*** SUITE 511 * (INVENTORY SUITE)**

SUITES 511 - NOYAC BAY (Inventory Suite)

25 Baker Hill Blvd - Stouffville, ON Apr 04, 2018

SUITE 511
ORIGINAL LAYOUT
INVENTORY SUITE
NEXT LAYOUT

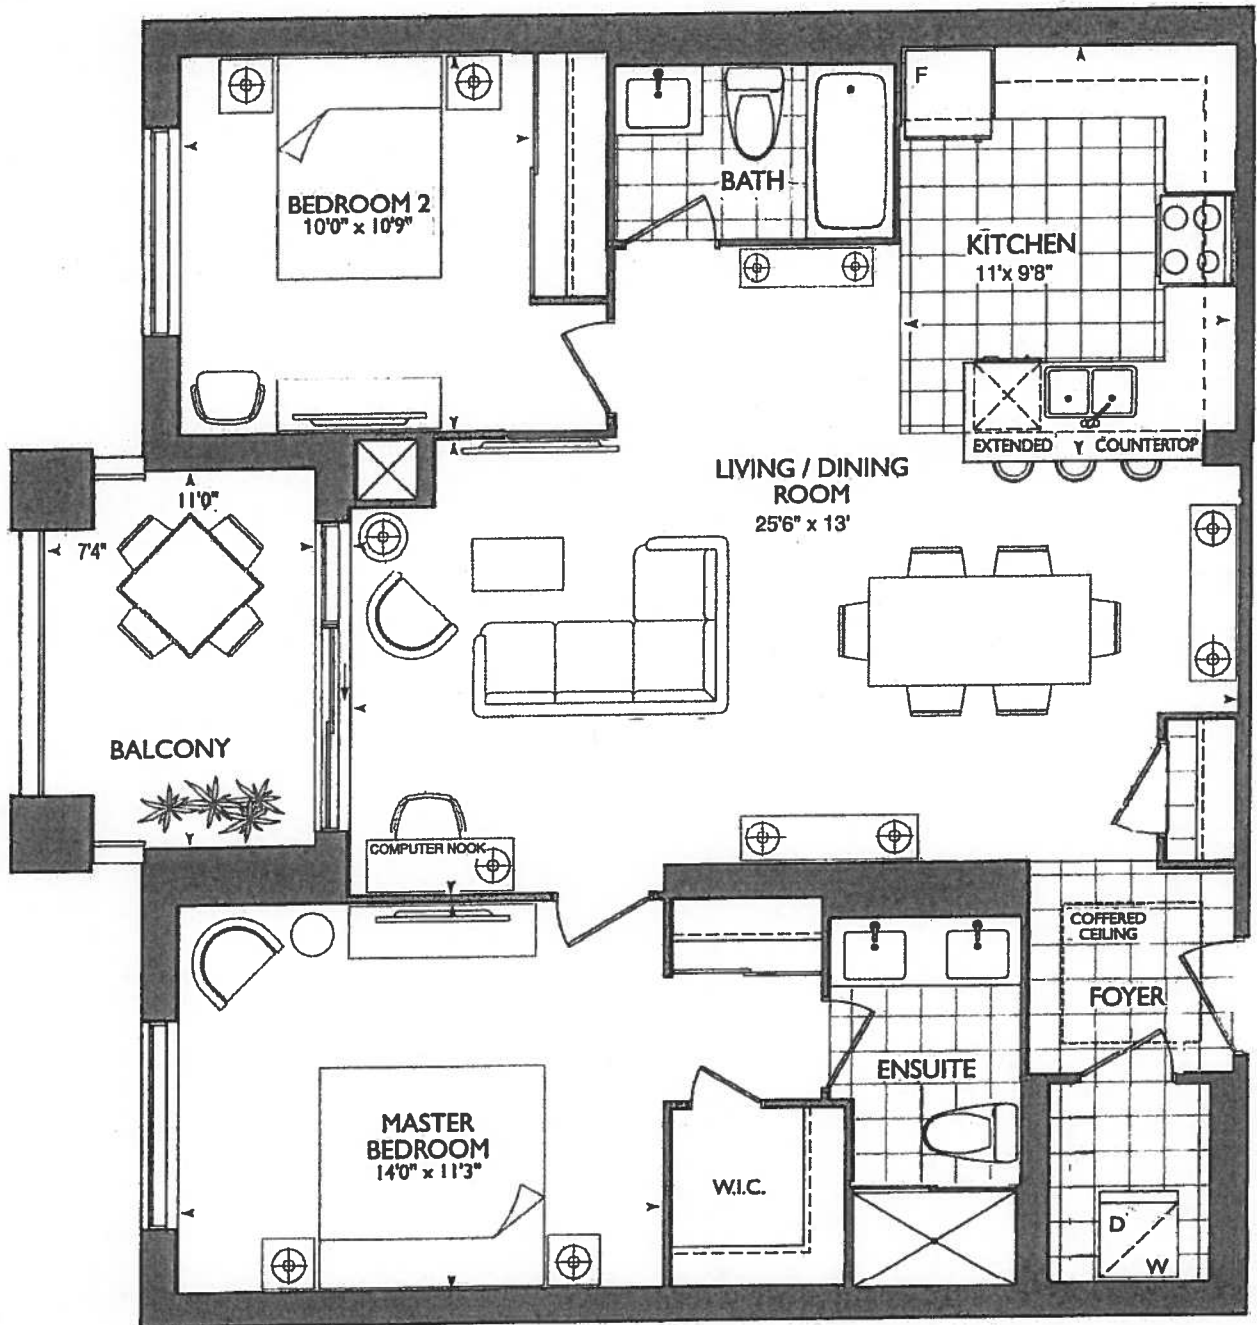
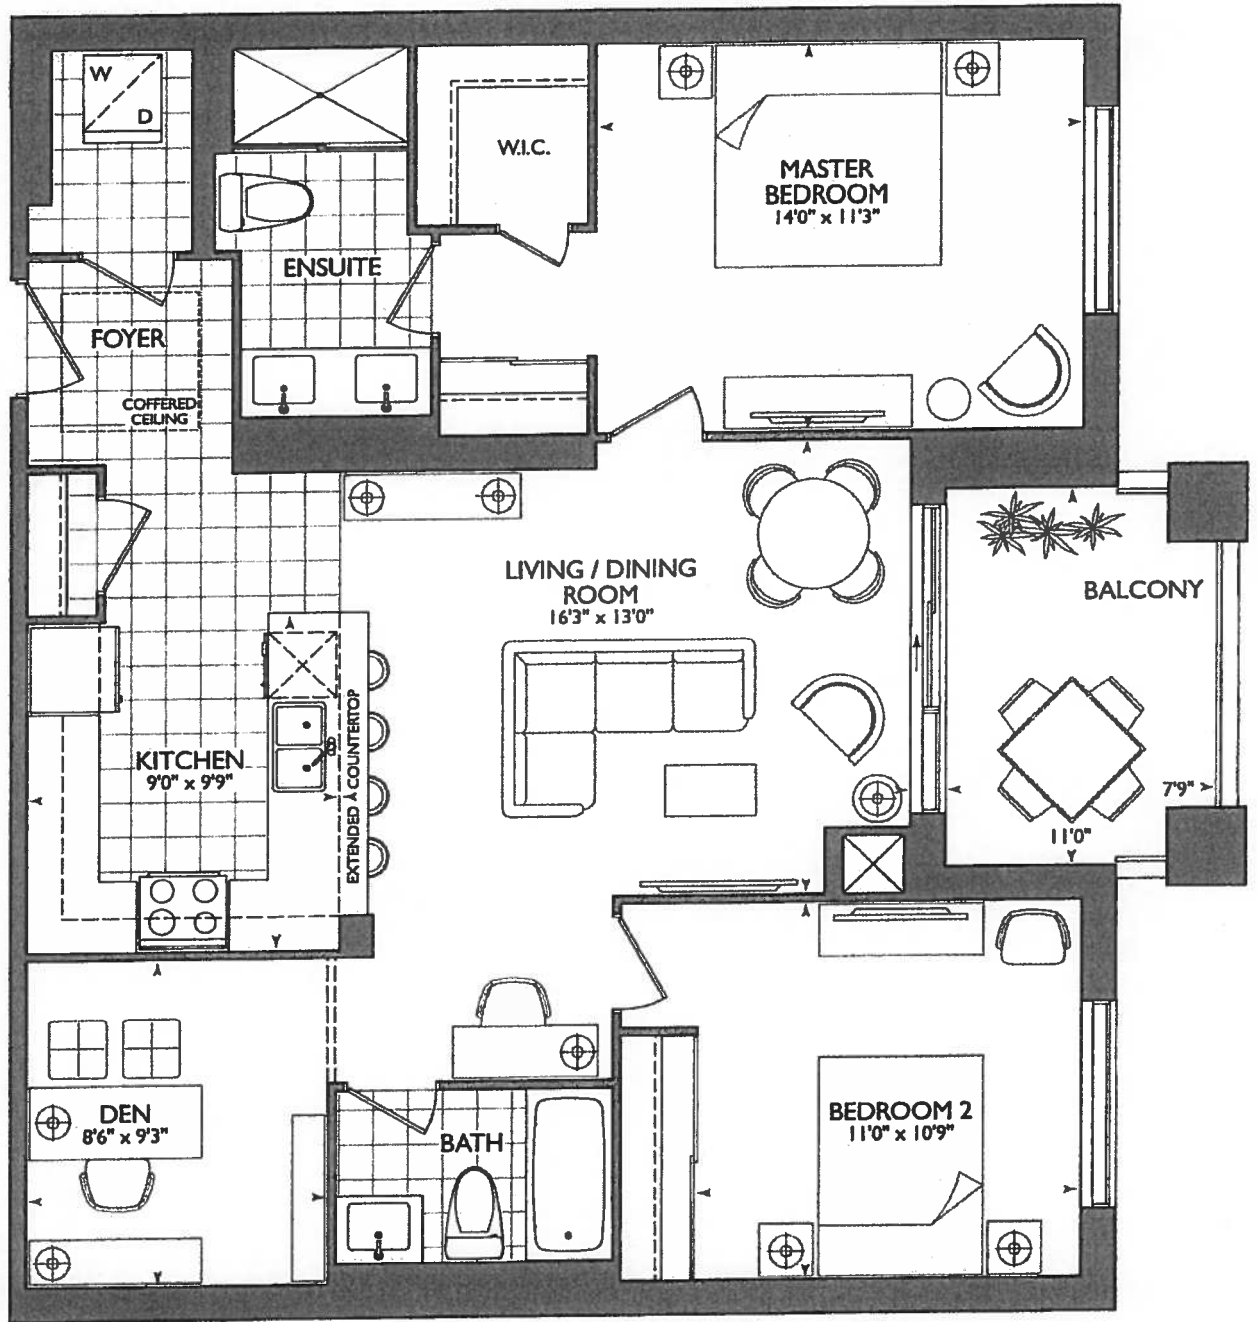
- NEW KITCHEN
- REMOVED DEN
- REVISED KITCHEN

***REVISED LAUNDRY DOOR SWING &
ENSUITE WALL AS PER THIS BROCHURE**

#1- KITCHEN LAYOUT WITH 1ST UPG.
APPLIANCE PACKAGE

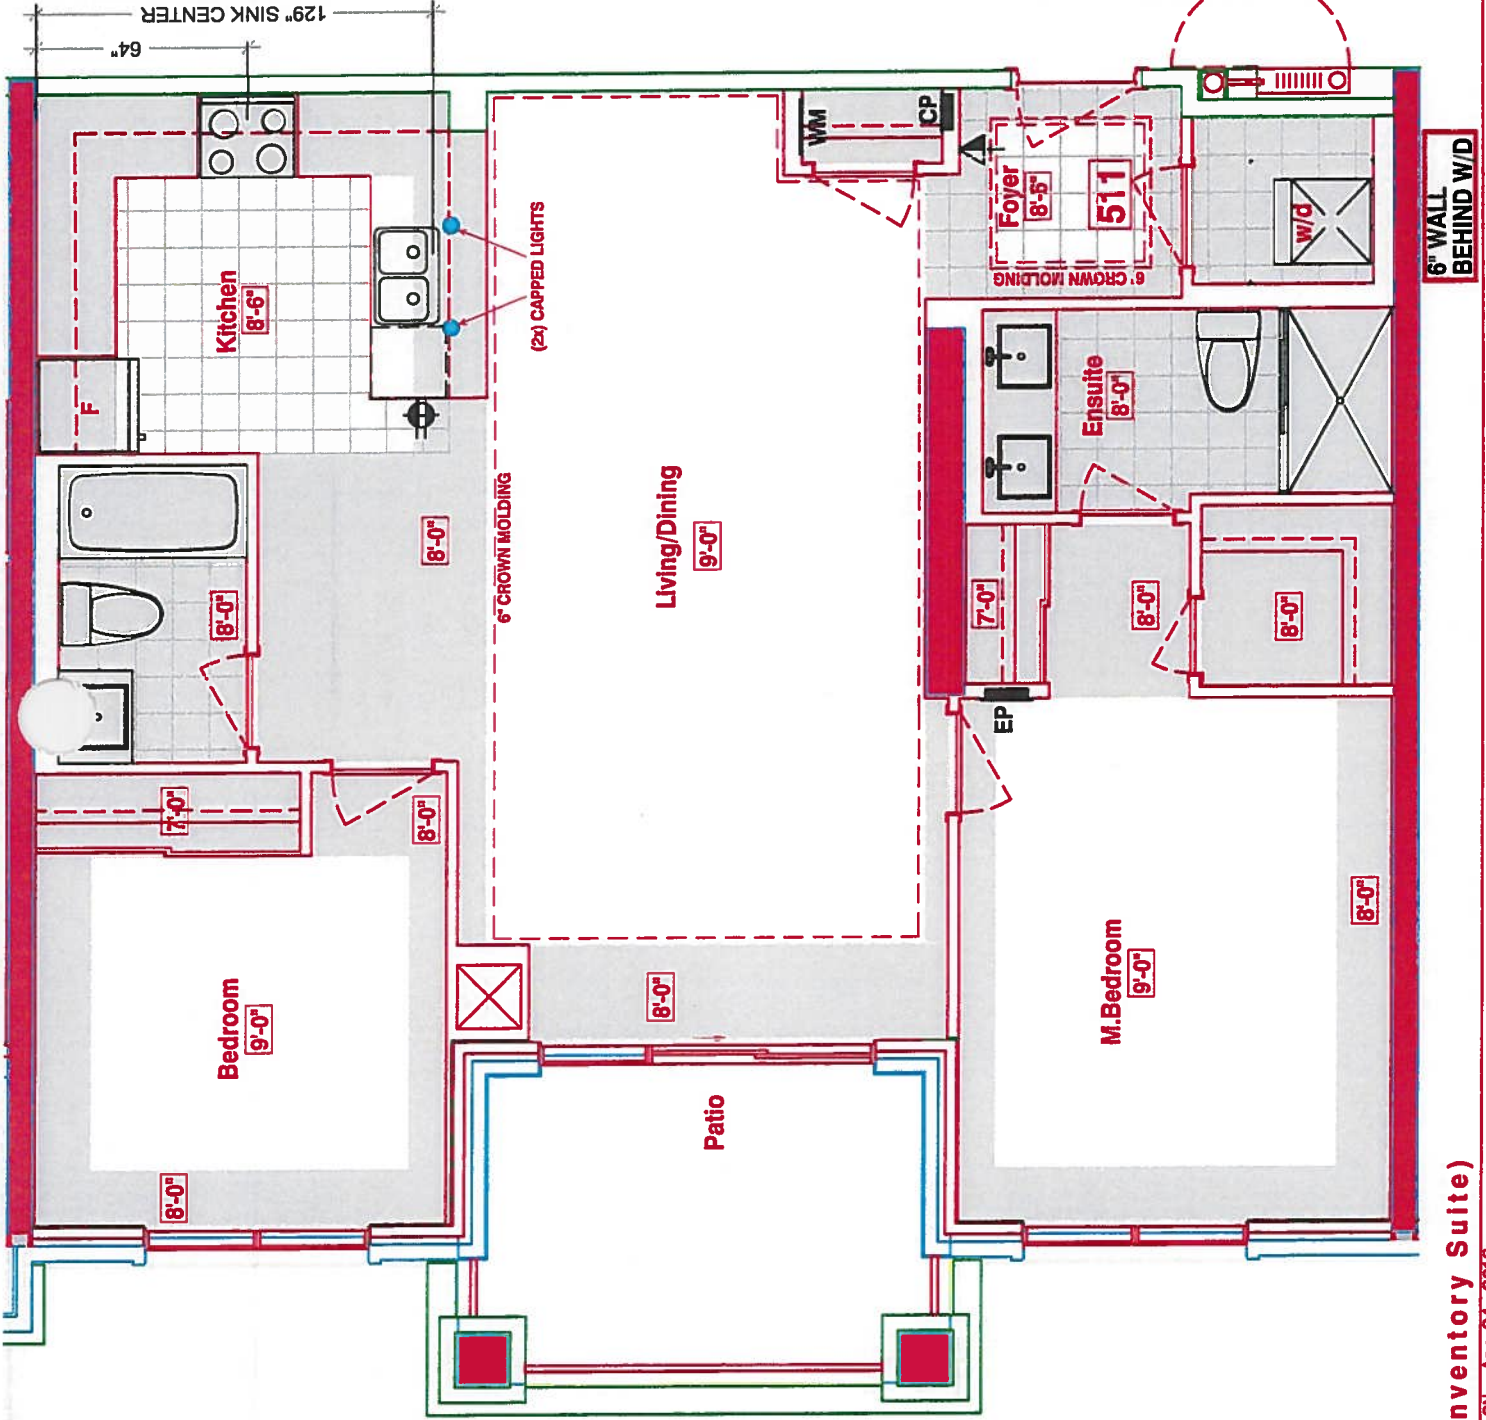
*** KITCHEN ***

CHOICE OF STD. KITCHEN LAYOUT, WITH
STD. APPLIANCE PACKAGE

OR

CAN UPGRADE AT DECOR CENTER

- (x2) CAPPED PENDANT
- (x1) PLUG PENINSULA
- (x) PUCK LIGHTS
